573.6 Defect Information Report

Victory has determined that the welded joint on the shift lever shaft may fail causing the shift lever to become inoperable.

Bulletin Number: V-06-04

SUBJECT: Shift Lever Shaft Weld Failure

SPECIAL INSTRUCTIONS FOR SHIFT LEVER SHAFT REPLACEMENT:

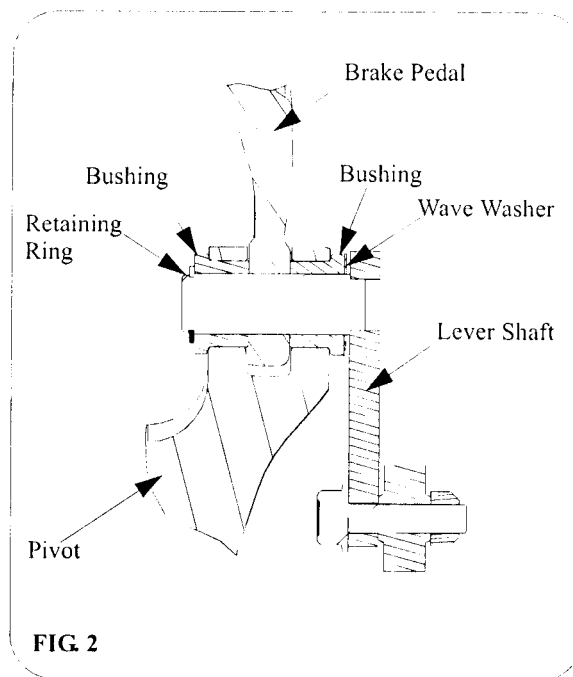
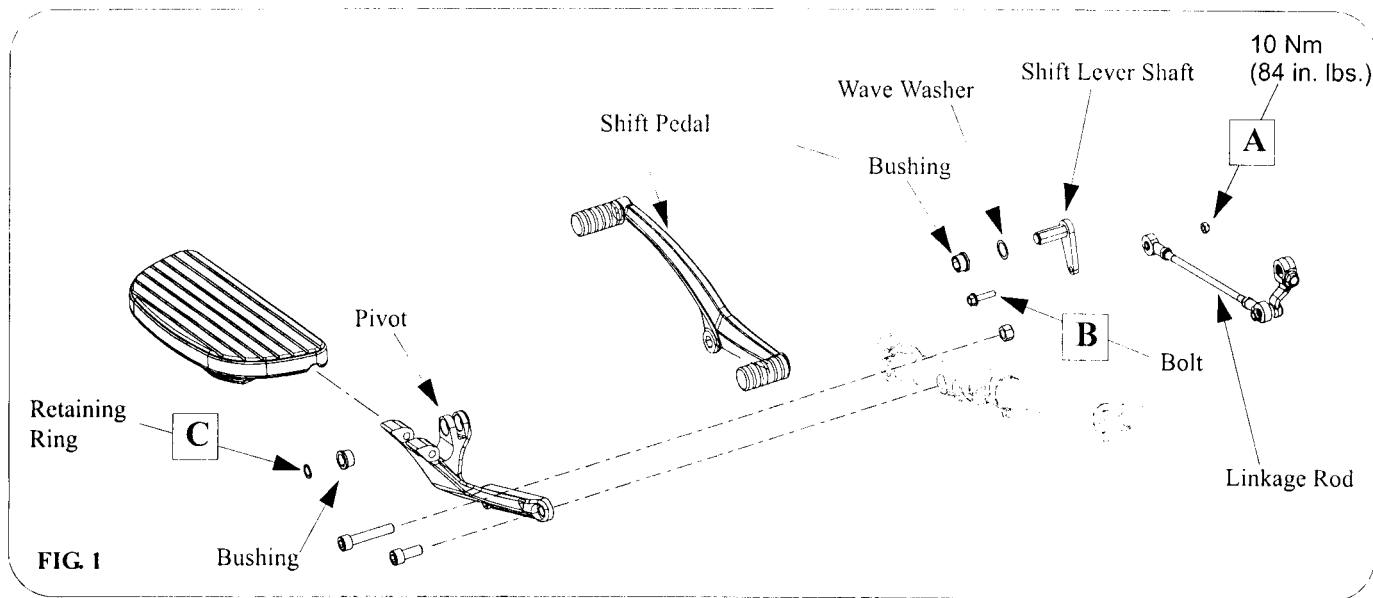
The welded joint on the shift lever shaft may fail, causing the shift pedal to become inoperable. The inability of an operator to shift gears increases the risk of a crash.

1. Disconnect linkage rod by removing nut (A) and bolt (B).
2. Remove retaining ring (C).
3. Remove shift lever shaft.
4. Remove wave washer from existing shaft and install on new shaft.
5. Grease pedal bushings and shift pedal and re-assemble as shown. (See Fig. 2.)
6. Install pedal onto pivot and insert new shaft, aligning the flats of shaft with the bushings.
7. Install retaining ring. Be sure ring is fully seated in the groove of new shaft.
8. Install linkage bolt and nut. Torque nut to 10 Nm. (84 in. lbs.).
